Three Mile Island Nuclear Station, Unit 1  
Facility Operating License No. DPR-50  
NRC Docket No. 50-289

Subject: Technical Specification Change Request No. 342  
Control Rod Drive Control System Upgrade and Elimination of the Axial  
Power Shaping Rods

**Attachment 1**  
**TMI-1 Evaluation of Proposed Changes for the Control Rod Drive Control System**  
**Upgrade and Elimination of Axial Power Shaping Rods**

Figure 1

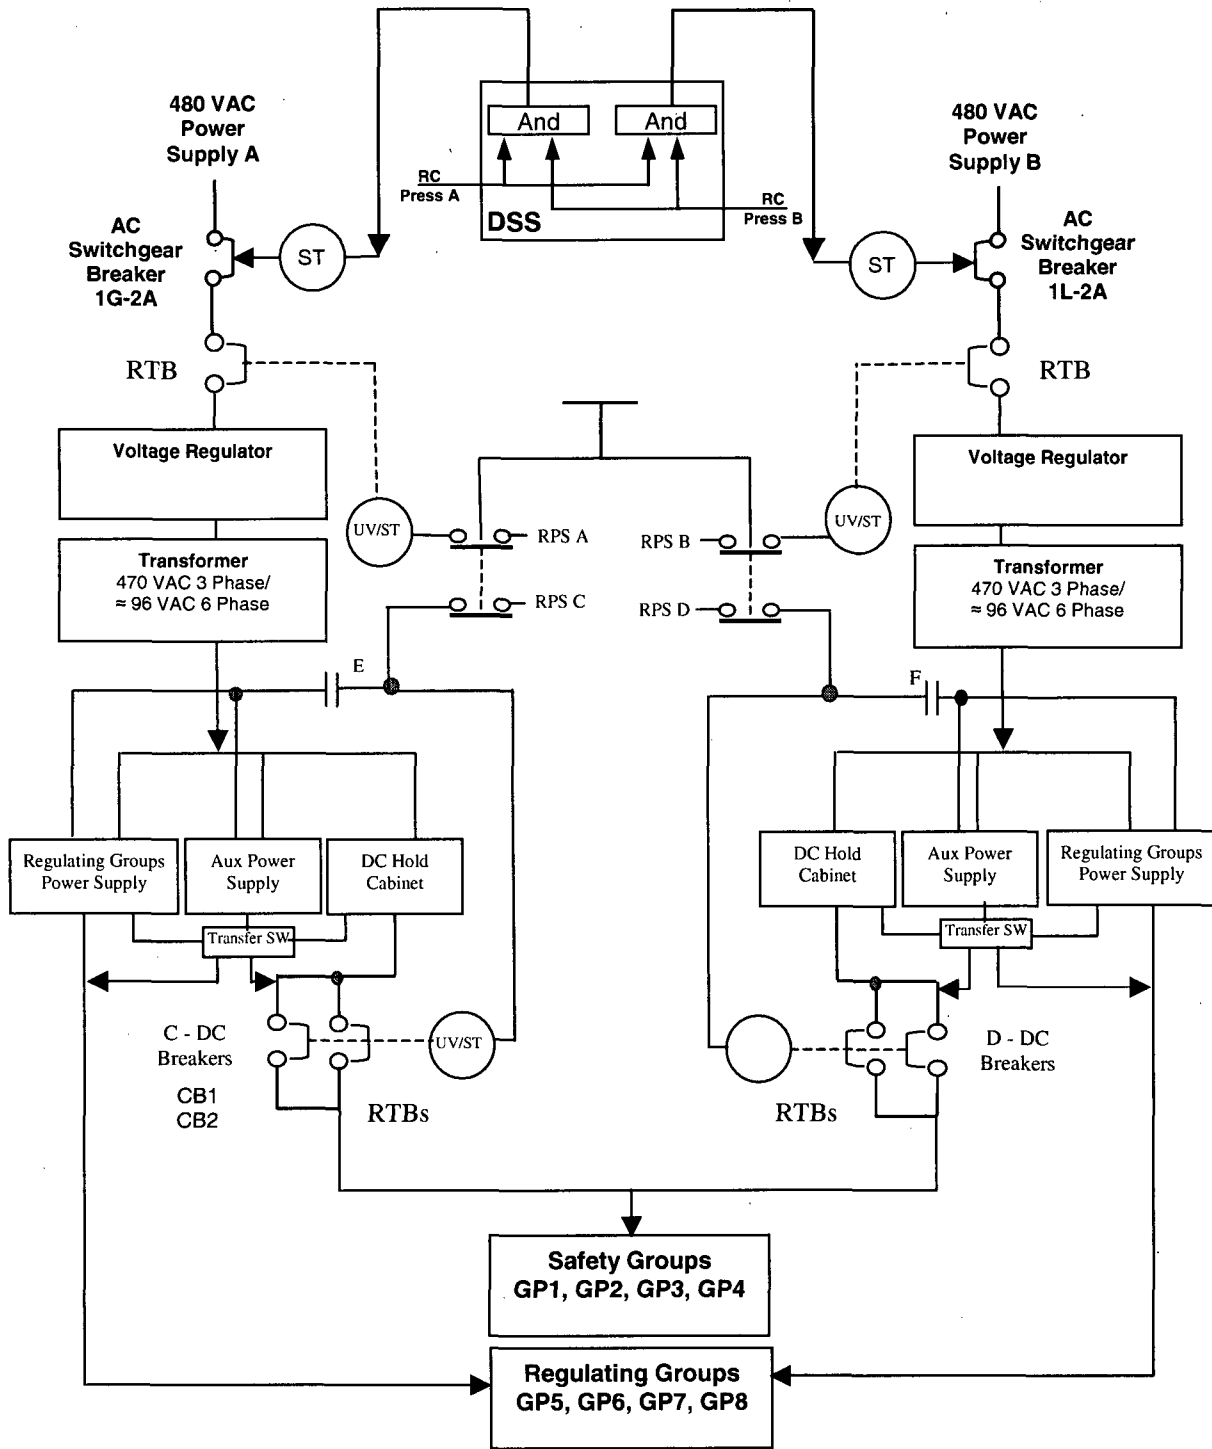
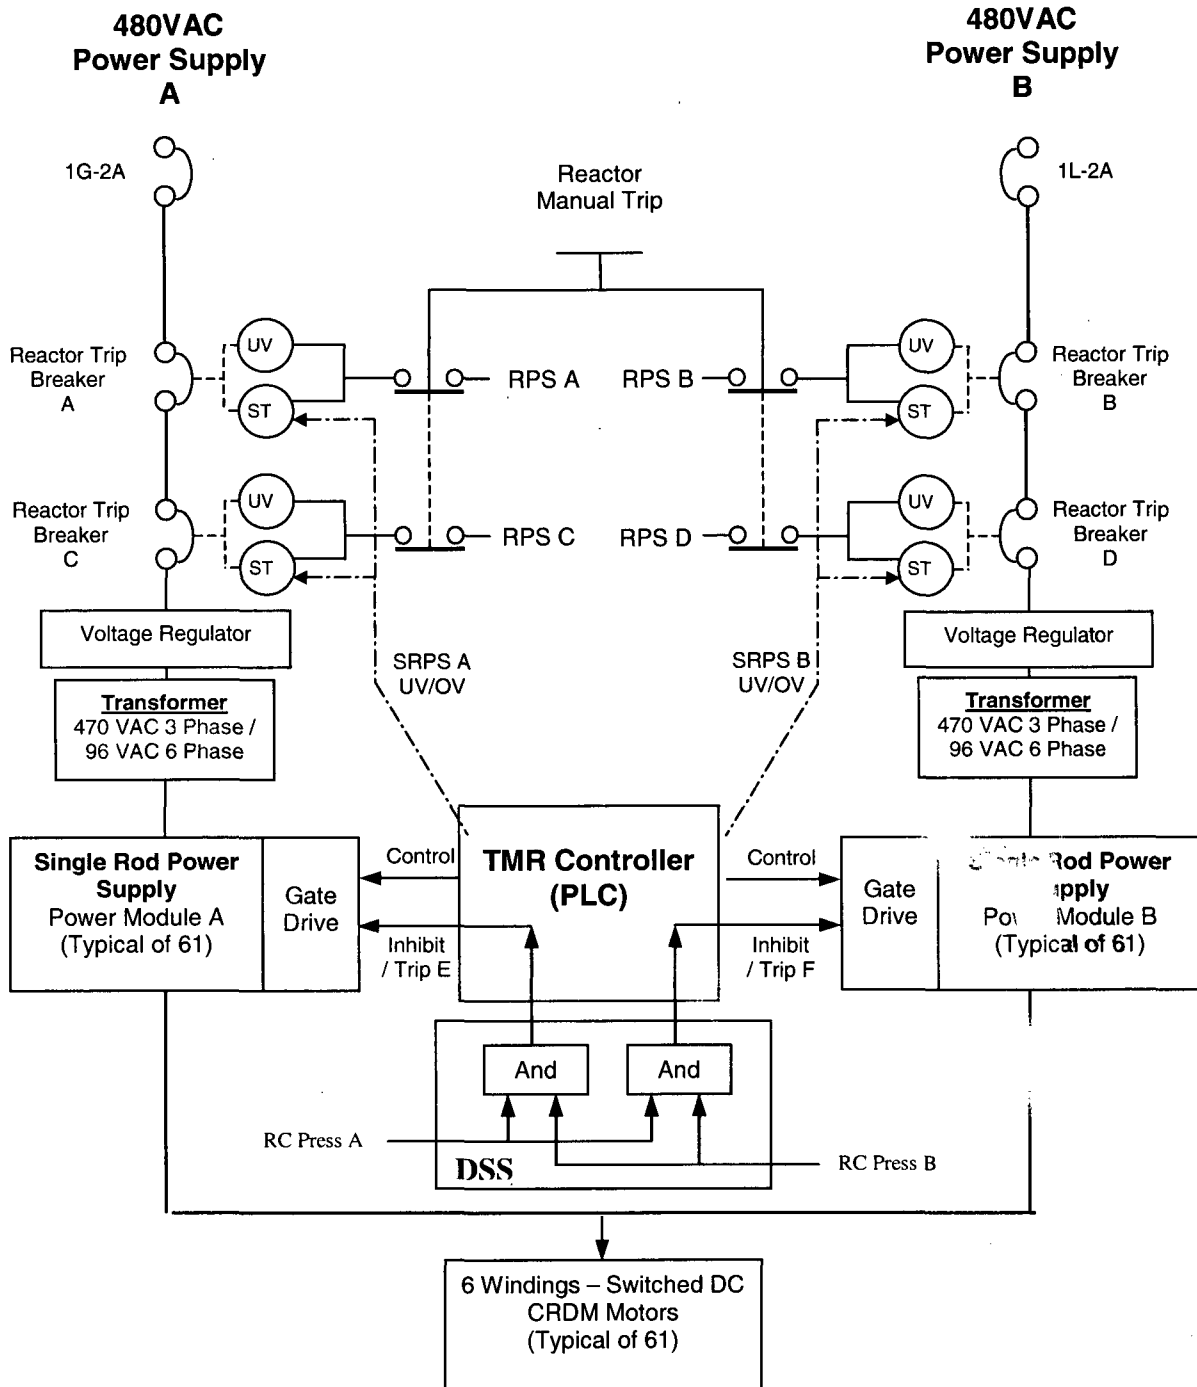
The existing TMI-1 CRDCS is being replaced with a digital CRDCS (DCRDCS). The existing relay-based CRDCS (refer to Figure 1 for a simplified diagram) is being upgraded to a redesigned system (refer to Figure 2 for a simplified diagram) to resolve obsolescence and age-related degradation issues. The RTBs are reconfigured to accommodate the new control system; however, the reactor trip function is independent of the digital system. The replacement of the RTBs is not considered a digital upgrade. The digital system provides Control Rod Position Indication but does not perform any nuclear safety related function.

The DCRDCS will require a TS change to allow implementation, specifically for: 1) replacement of the existing two alternating current (AC) RTBs and four existing direct current (DC) RTBs with four new AC RTBs; 2) deletion of the Electronic Trip Assemblies (ETAs) associated with the DC RTBs; and, 3) replacement of the patch panels with software control as the means to assign control rods to their groups. The TS changes described above are the only aspects of the DCRDCS project that require NRC approval prior to implementation. The DCRDCS design change is being evaluated under Engineering Change Request (ECR) TM 07-01037 (Reference 1).

The revised RTB configuration being installed as part of the DCRDCS modification will replace the existing two AC RTBs and four DC RTBs with four new AC RTBs. Breakers A and C are placed in series in one parallel power path, and breakers B and D are in series in the other parallel path. All of the 3-phase primary power to the rod drives is via these parallel paths. In the revised configuration, RPS Channel A trips CRD breaker A, Channel B trips breaker B, Channel C trips breaker C, and Channel D trips breaker D. The one-out-of-two-times-two trip logic is maintained. The new RTB configuration of four qualified breakers maintains the safety design basis of the CRD system in that upon receipt of the RPS signals the RTBs in the power feed circuits are tripped, which removes power upstream of the SRPSs. The new RTBs are fully qualified for this safety related application. Each RTB has diverse trip devices including an undervoltage device that is de-energized to trip and a shunt trip device that is energized to trip. The RPS and RTBs are diverse from the DSS / Anticipated Transient Without Scram (ATWS) System. As with the existing system configuration, no single breaker failure will prevent a reactor trip when required or cause a reactor trip when not required. The one-out-of-two-times-two logic scheme described above will be maintained utilizing significantly less components.

The new RTB configuration will continue to provide the same design function as the existing configuration by removing power to the CRDMs to initiate a reactor trip. The new configuration will utilize qualified breakers to accomplish this function, and it will continue to meet the design function given a single failure. The revised configuration also uses fewer components to meet the original design requirements, and is therefore simpler than the existing design. Figure 2 shows the modified simplified diagram for the DCRDCS and RTB configuration.
